## Modifications to ECE/TRANS/WP.29/GRSP/2025/7\*

The text reproduced below was prepared by TF-R134, involving France, Japan, the Kingdom of the Netherlands, the European Commission, the European Association of Automotive Suppliers (CLEPA) and OICA, as well as related industry experts on transposing amendment 1 to UN Global Technical Regulation (GTR) No. 13, Phase 2 into a UN Regulation under the 1958 Agreement. It is a further development of GRSP-76-14-Rev.1 and GRSP-76-43 (see also paragraph 31 of ECE/TRANS/WP.29/GRSP/76). Amendments to UN Regulation No. 134, as amended in the seventy-sixth session of the Working Party on Passive Safety (see paragraph 30 and annex IX of ECE/TRANS/WP.29/GRSP/76), are marked in bold for new or strikethrough for deleted characters. The amendments to working document ECE/TRANS/GRSP/2025/7 are marked in red and blue.

\* Proposal for the 03 series of amendments to UN Regulation No. 134 (Hydrogen and fuel cell vehicles)

Model A

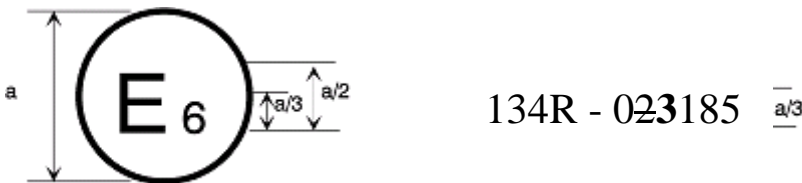
The above approval mark affixed to a vehicle/ storage system/specific component shows that the vehicle/storage system/specific component type concerned has been approved in Belgium (E 6) for its the safety-related performance of hydrogen-fuelled vehicles pursuant to Regulation No. 134. The first two digits of the approval number indicate that the approval already contained the 023 series of amendments at the time of approval.

Model B

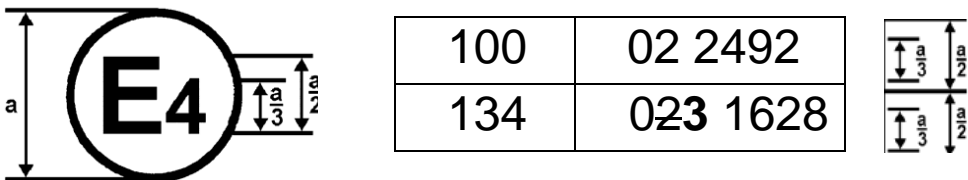
The above approval mark affixed to a vehicle shows that the road vehicle concerned has been approved in the Netherlands (E 4) pursuant to Regulations Nos. 134 and 100.\* The approval number indicates that, at the dates when the respective approvals were granted, Regulation No. 100 was amended by the 02 series of amendments and Regulation No. 134 was amended by the 023 series of amendments.”
